IMPROVEMENT PLANS FOR BERNARDO AVENUE & EVELYN AVENUE

S.W. CORNER OF
CITY OF MOUNTAIN VIEW
CALIFORNIA

SHEET 1 OF 1 SHT.

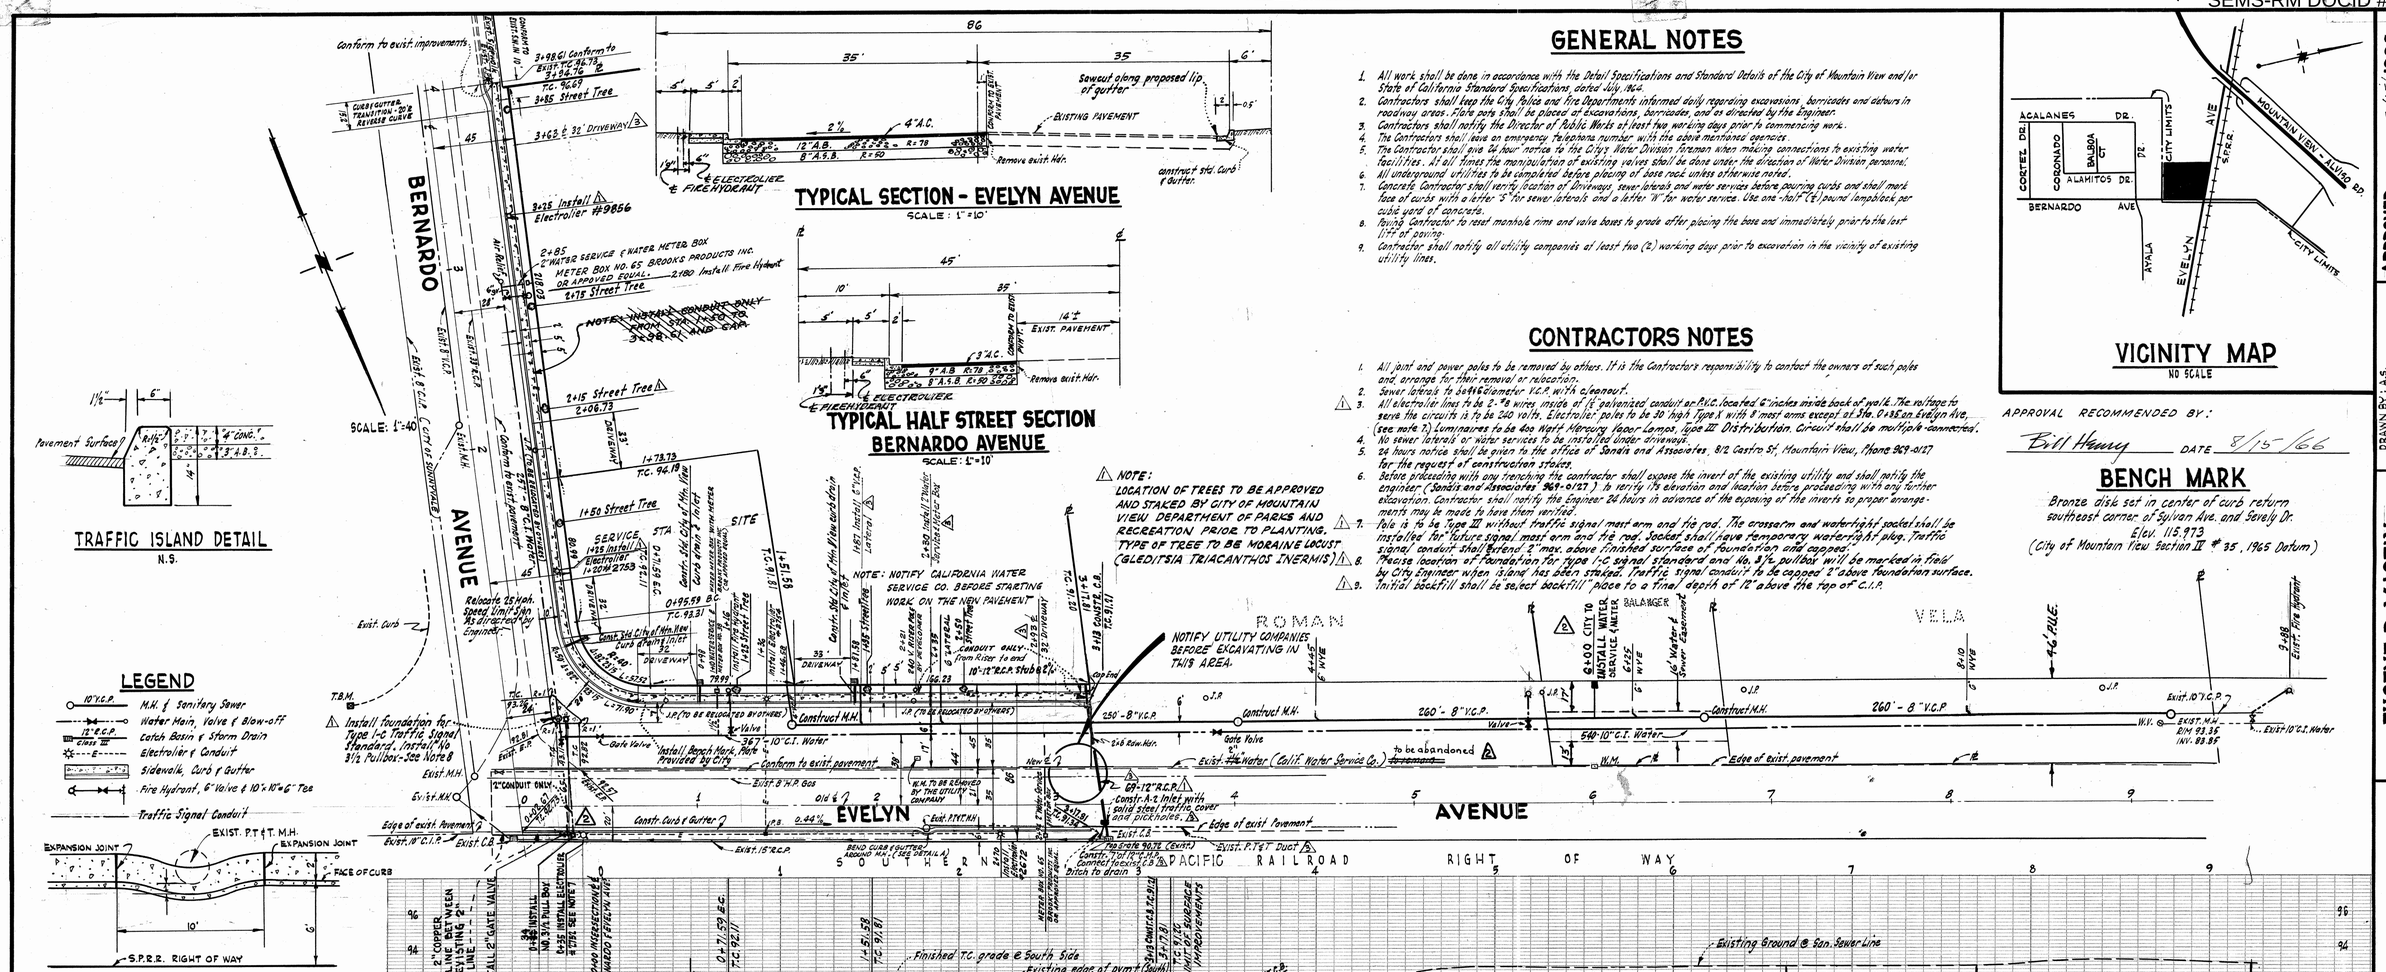
△4 REVISIONS: 12-18-1969 - RELOCATION OF DRIVEWAYS CONSTRUCT A-2 INLET - ADDED SEW. LAT. & WATER SERVICE CONSTRUCT 7' OF 12" CMP OVER EXIST. PT & T DUCT

△2 REVISIONS: 12-1-69 INSTALL 12" CIP WITH 12" GATE VALVE INSTALL 2" MAIN BETWEEN 12" CIP & EXISTING 2" MAIN INSTALL 2" GATE VALVE IN METER BOX STATION 0+31 INSTALL 2" WATER SERVICE W/ 3/4" METER STATION 6+00

△1 REVISIONS: 7-8-69 REVISED IN ACCORDANCE WITH CITY OF MOUNTAIN VIEW REQUIREMENTS, BY SANDIS & ASSOCIATES
